# Access Compliance Report

## Public Rights-of-Way

Intersection ID: N/A	Main Street: DIXIE_RIVER_RD	Cross Street: N/A	Location: N
ADA ID: 85066D4DD153	Ramp Type: PerpDiag	Initial Pass/Fail: Fail	Overall Compliance: No
		Severity Score: 30

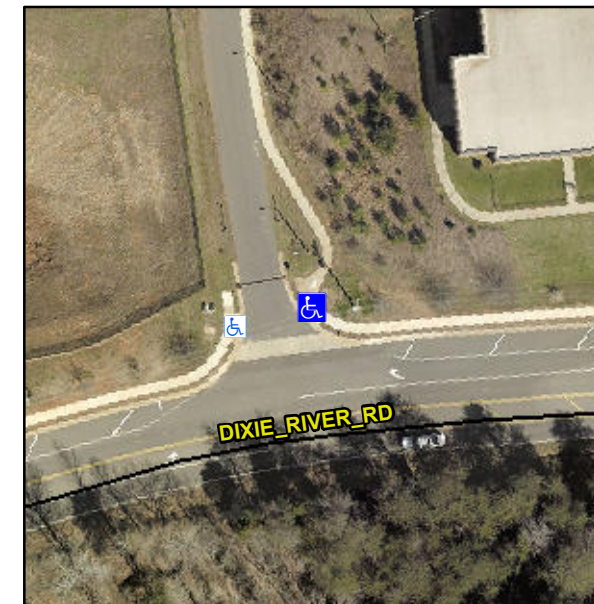
**Not Found, R304.5.1, R304.2.2**

Compliance	Description	Data	Compliance	Description	Data
N/A	Ramp Length (in)	96.0	No	Ramp Slope (%)	9.3
No	Ramp Width (in)	35.0	Yes	Ramp XSlope (%)	1.1
N/A	Flare Type LT	N/A	N/A	Flare Type RT	N/A
N/A	Flare Slope LT (%)	N/A	N/A	Flare Slope RT (%)	N/A
N/A	Flare Traversable LT?	N/A	N/A	Flare Traversable RT?	N/A
N/A	Landing Length (in)	N/A	N/A	DWS Provided?	N/A
N/A	Landing Width (in)	N/A	N/A	DWS Contrast?	N/A
N/A	Landing Slope (%)	N/A	N/A	DWS Length (in)	N/A
N/A	Landing X Slope (%)	N/A	N/A	DWS Full Width?	N/A
N/A	Landing Curb? (Y/N)	N/A	N/A	DWS Offset (in)	N/A
N/A	Shared Landing?	N/A			
N/A	Gutter Ponding?	N/A	N/A	Gutter Slope (%)	N/A
N/A	Gutter Lip Ht (in)	N/A	N/A	Gutter X Slope (%)	N/A
N/A	Painted X Walk1?	No	N/A	Painted X Walk2?	No
	X Walk 1 Direction	To W		X Walk 2 Direction	To S
N/A	X Walk 1 Width (in)	N/A	N/A	X Walk 2 Width (in)	N/A
	X Walk 1 Slope (%)	2.6		X Walk 2 Slope (%)	0.6
	X Walk 1 X Slope (%)	1.1		X Walk 2 X Slope (%)	2.9

**Remove & Replace Curb Ramp With Two New Directional Ramps or Equivalent.**
